Wireless Link Planning and RF Engineering

Atma to Al-Sharq backhaul and seven-zone distribution

The implemented network links Atma to Al-Sharq through the MTN tower area. This engineering review joins source requirements, authentic simulation captures, reproducible RF calculations and a commissioning evidence plan.

H1: PowerBeam M5 400

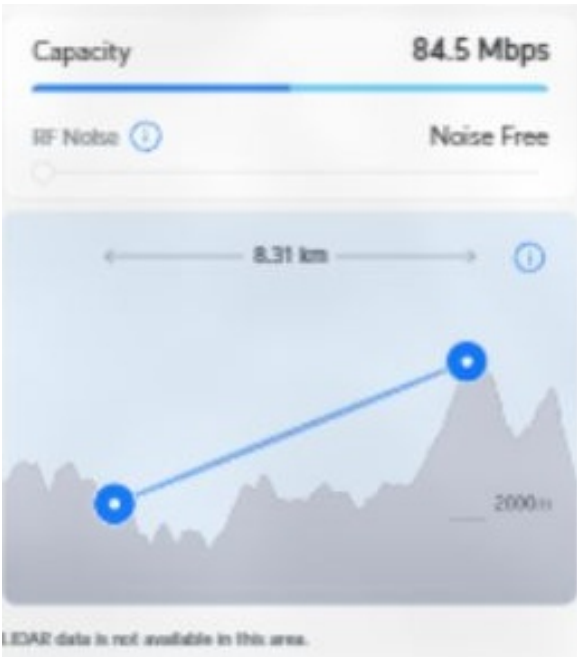
UISP reports that LIDAR data is unavailable in this area. Its frequency and loss assumptions differ from the independent 5.8 GHz calculation. The displayed 84.5 Mbps is vendor-predicted capacity, not an iperf measurement or a guaranteed end-to-end service rate.

H1 actual calculation output from the retained terrain dataset.

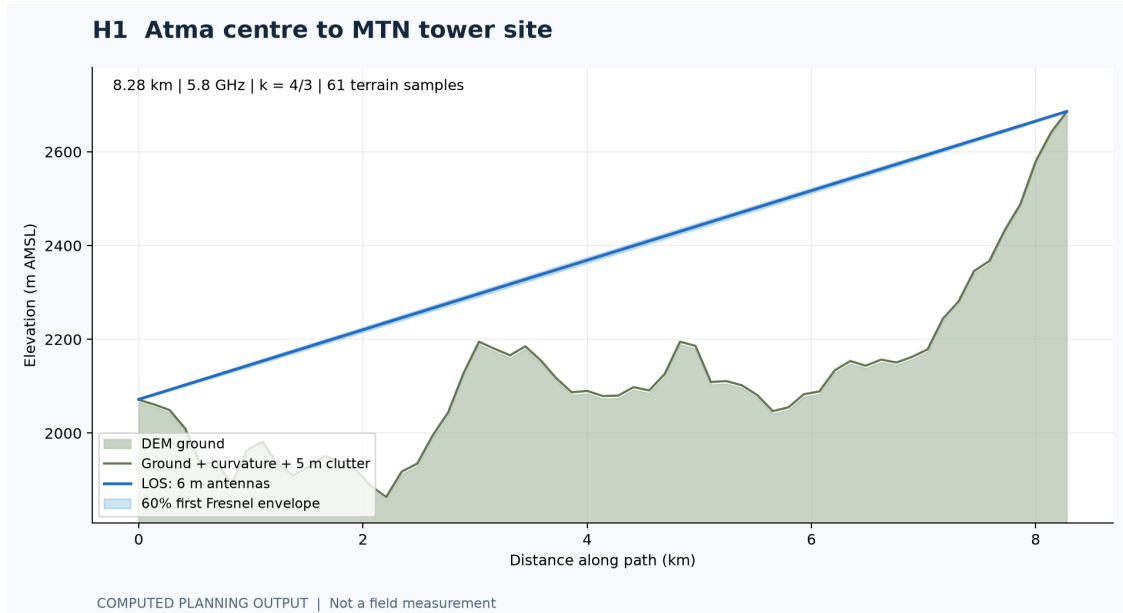
The nominal sampled paths clear 60% of the first Fresnel zone. The midpoint first-zone radii are about 10.34 m and 14.18 m at 5.8 GHz. Curvature is applied once, with $k = 4/3$. Ground elevations are in metres above mean sea level; antenna heights are above local ground.

These profiles do not resolve every tree, rooftop or narrow ridge. A direct survey of the endpoint approaches remains necessary. A zero-height result from a sparse model is not an installation height recommendation.

Sensitivity to EIRP cap at MCS15. Caps are examples, not regulatory advice.

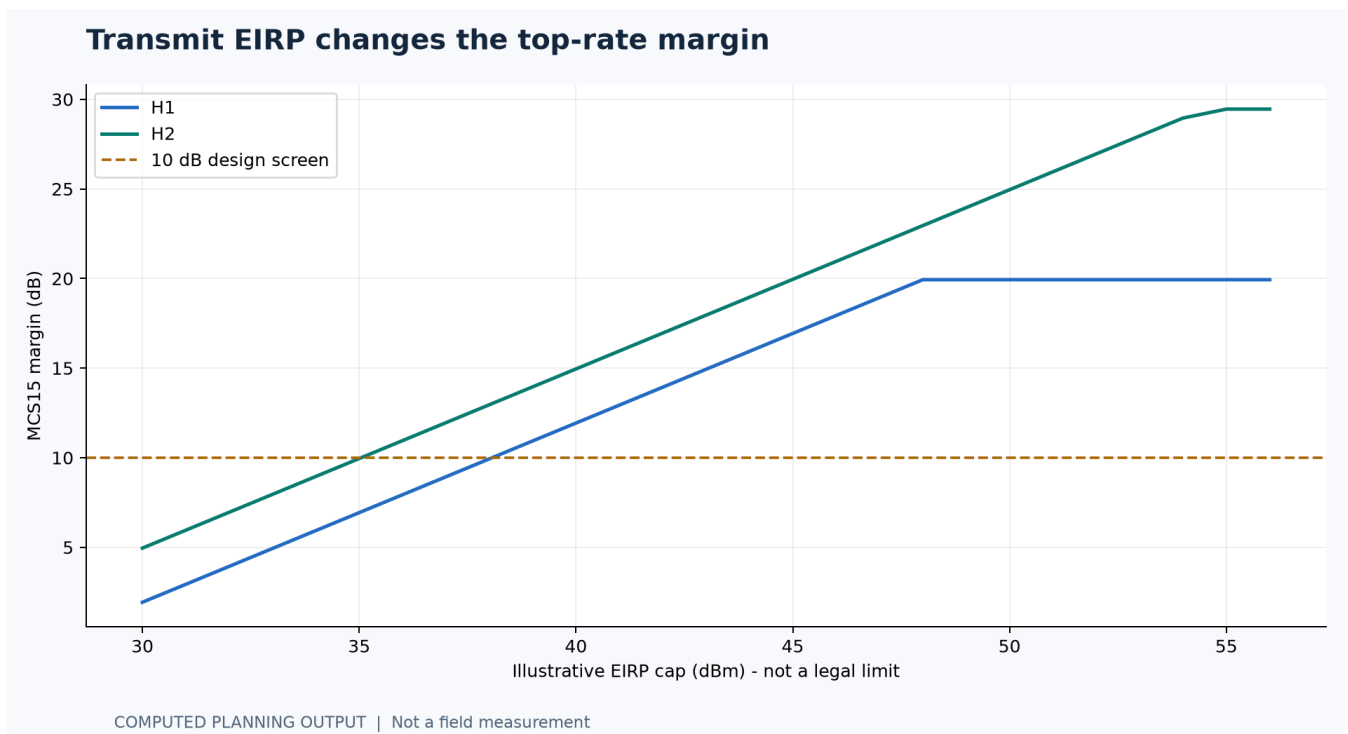
Hardware maximum TX power is a capability input, not a permitted operating setting. The illustrative EIRP sweep shows how lower radiated power changes top-rate margin. It does not assert any legal EIRP limit for Yemen. Confirm the applicable band, channel, country profile and radiated-power limit.

For a 36 dBm illustrative EIRP cap, the MCS15 margins fall to 7.93 dB on H1 and 10.95 dB on H2. H1 then falls below the 10 dB screen at MCS15 and requires a lower modulation rate. Device TX and receiver sensitivity tolerances alone may consume another 4 dB.

Actual output of the scenario sensitivity calculation.

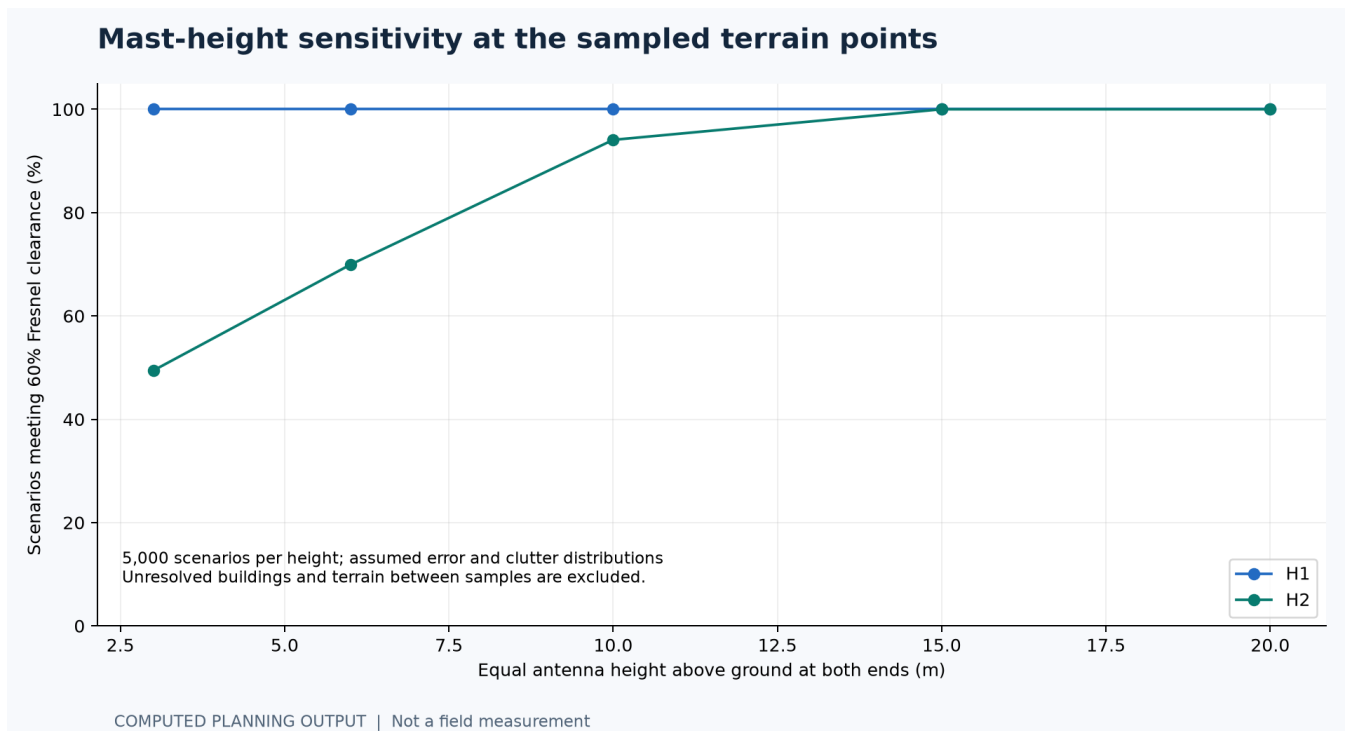
The Monte Carlo screen varies assumed DEM error, clutter up to 15 m and effective Earth factor in 5,000 scenarios per height. A scenario pass fraction is not uptime, a measured obstruction probability or a confidence level. Endpoint elevation error is fixed and terrain between samples is unresolved.

Increasing H2 mast height improves this sampled-point screen, but neither 10 m nor 15 m is a certified height. Surveyed clearance, safe access, foundation/mast structure, wind loading and permissions determine the final installation.

Original zone map from the project document. CNES / Astrium and Google attribution retained; coordinate bar excluded.

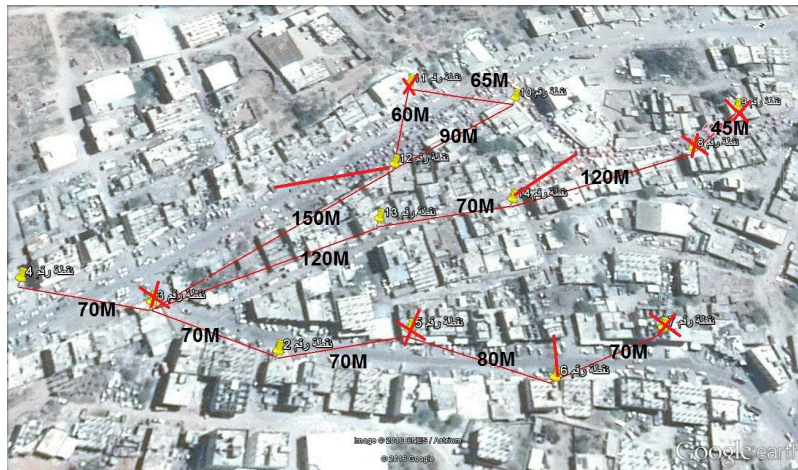
The original map identifies seven retained zones. The equipment totals are 16 NanoStation M2 units, six local PowerBeam units and one sector line. A NanoStation has a directional antenna; a nominal 500 m reach is not omnidirectional coverage or a guaranteed high-rate boundary.

The 5 GHz sector and 2.4 GHz NanoStation operate in different bands and cannot directly associate over RF. Confirm the sector radio, its exact SKU and any Ethernet interconnection. Coverage below assumes on-axis 11 dBi antennas at both ends, an $n = 3.2$ path-loss exponent and 8 dB shadowing; none is fitted to local measured coverage.
